Subject: Data Response, Set 2A
Hidden Hills Solar Electric Generating System (11-AFC-2)

(11-AFC-2)

Hidden Hills Solar Electric Generating System (HHSEGS)

**Data Response, Set 2A
(Response to Data Requests 136 through 143)**

FIGURE DR137-10
CNDDDB Results within 10 miles of Potential Solar Plant Alternative
 Solar Plant Alternative Site, Inyo County
 Hidden Hills Solar Electric Generating System

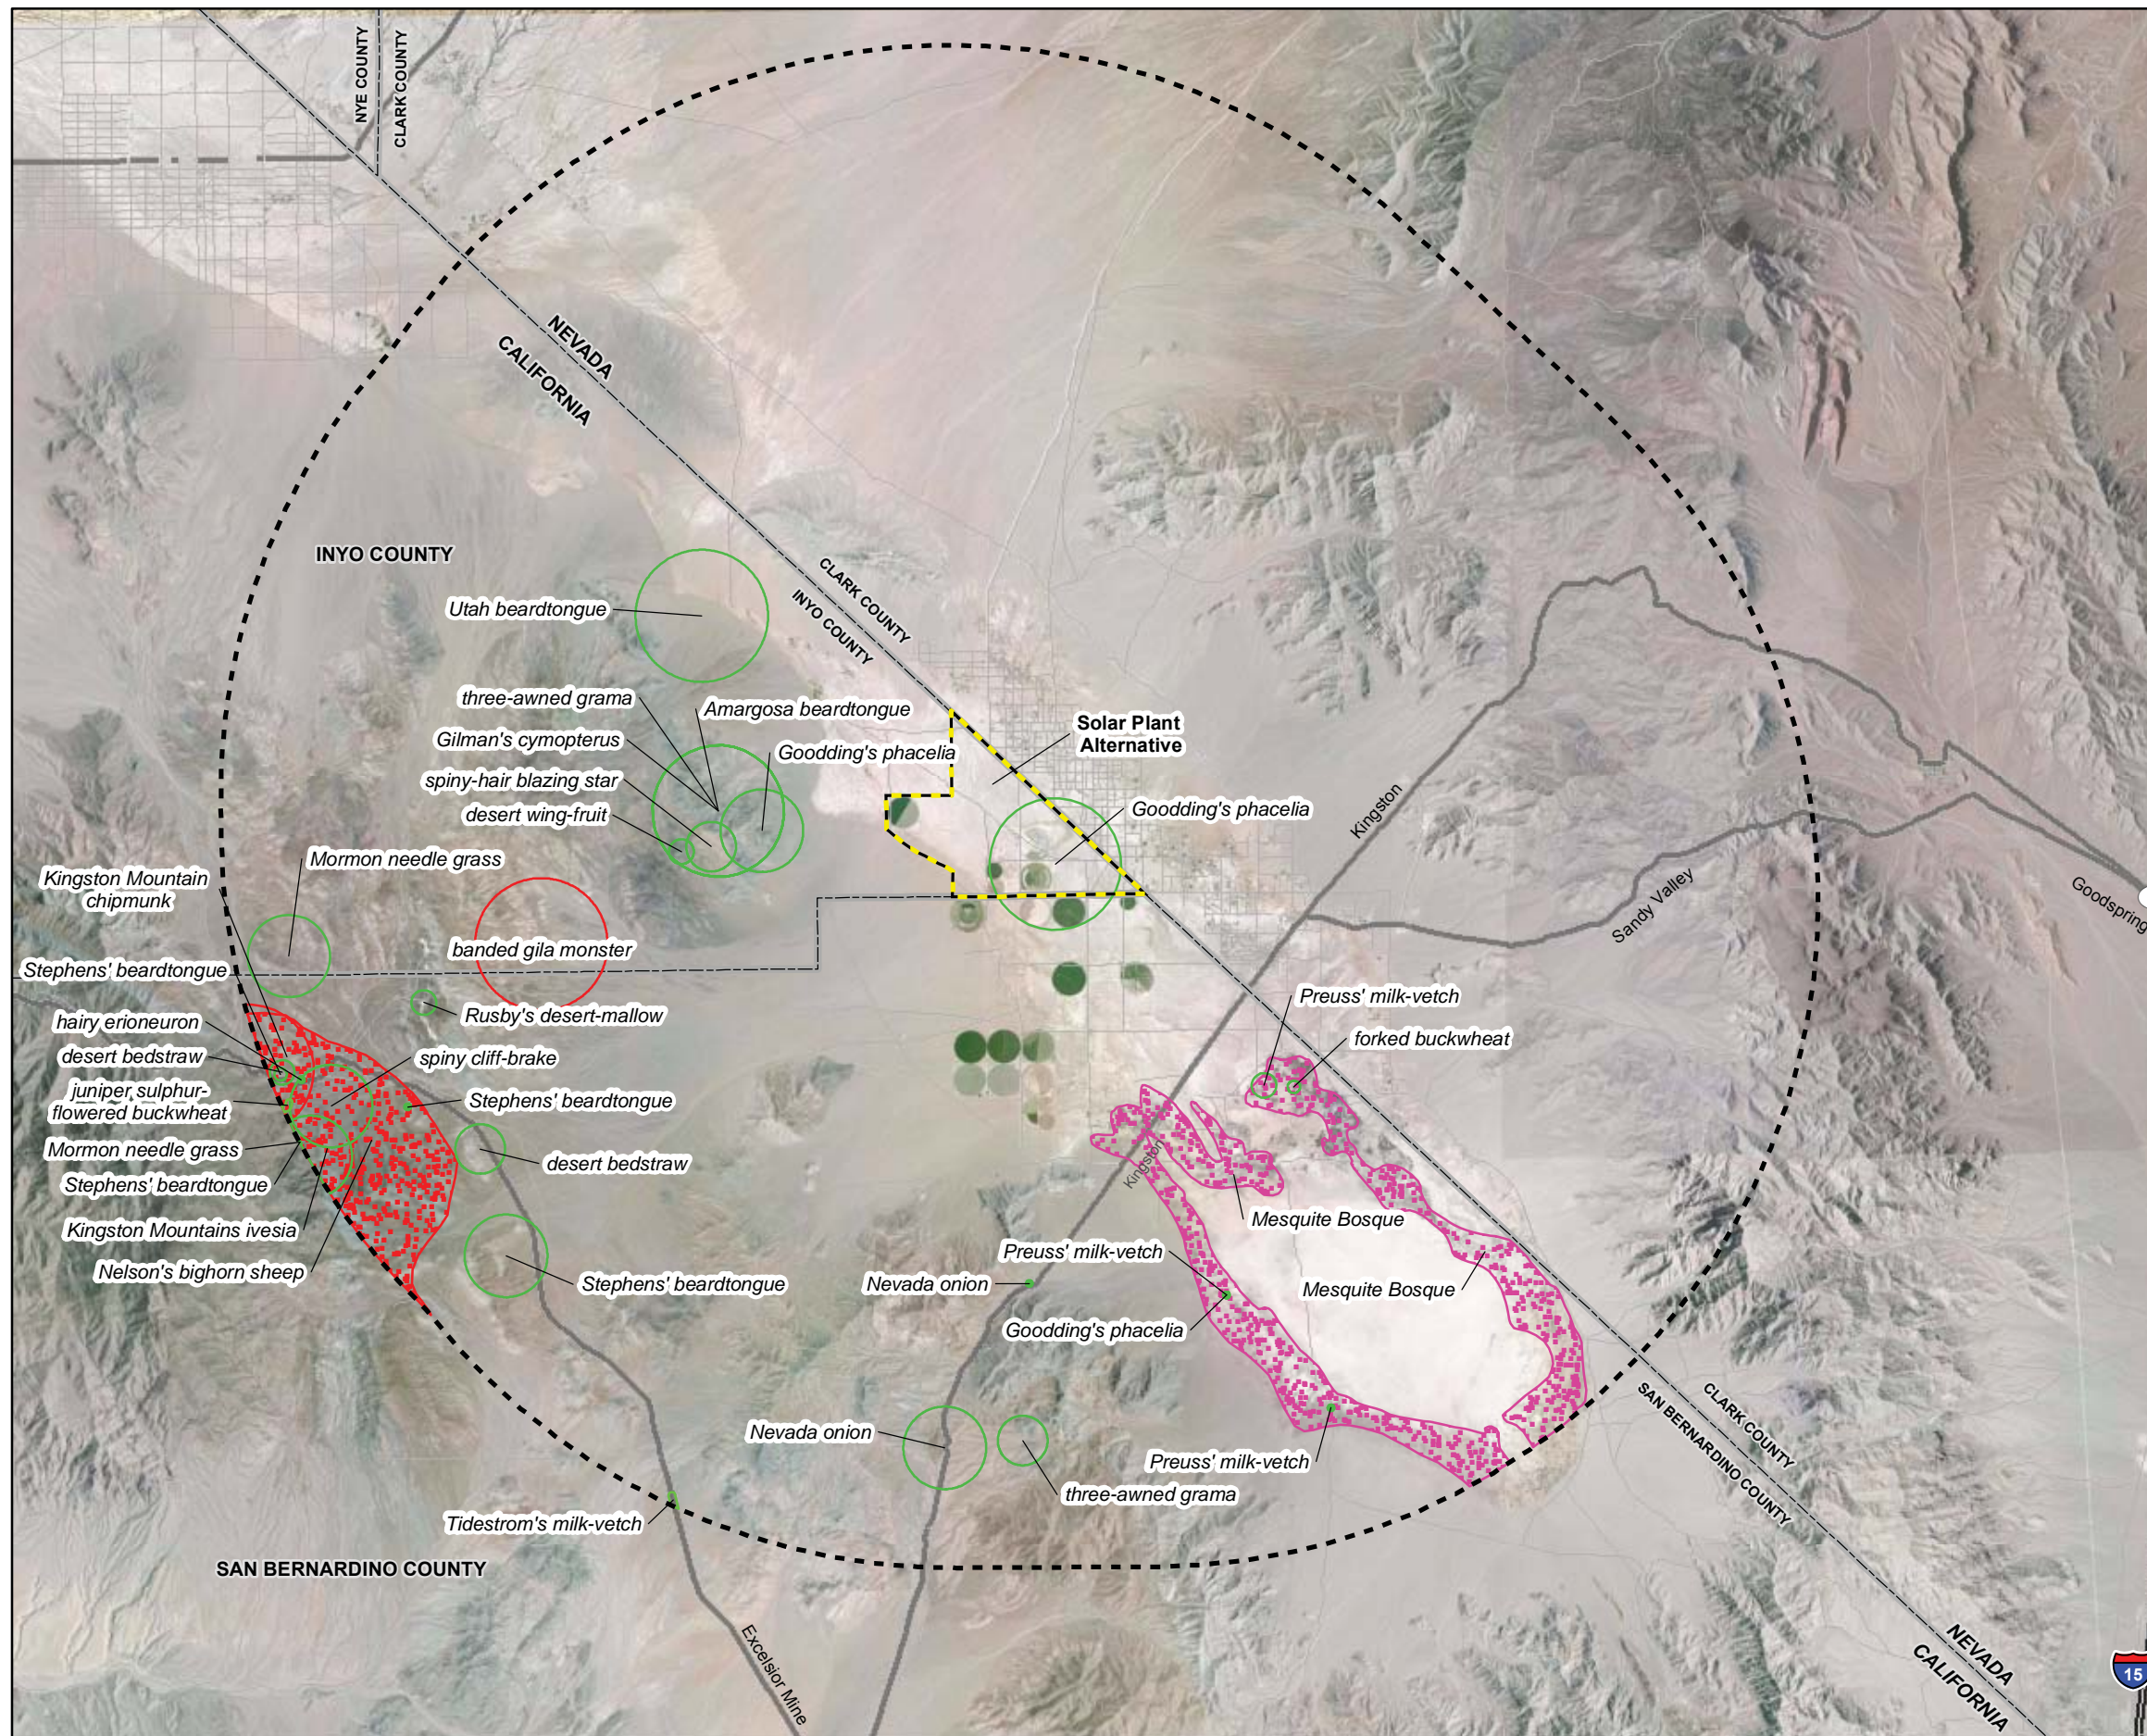
- l. Information on habitat types and protected plant and wildlife species that could be present in the area. Include data obtained from a California Natural Diversity Database record search for the area.

Response: Figure DR137-9 shows USGS desert tortoise habitat model results in the vicinity of the potential project alternative. In addition, Figure DR137-10 shows the results of a CNDDDB record search for a 10-mile radius from the site. The Solar Plant Alternative site is located in an area depicted with some suitable habitat for desert tortoise. Figure DR137-10 shows that some special-status plants have also been reported in that portion of the valley. However, with the presence of the current land uses, presence of desert tortoises and special-status plants on the privately owned parcels is less likely. However, they could be present on the BLM-managed lands. With the implementation of mitigation measures, and in compliance with state and federal endangered species act requirements, impacts to desert tortoise and any special-status plants would be mitigated to acceptable levels.
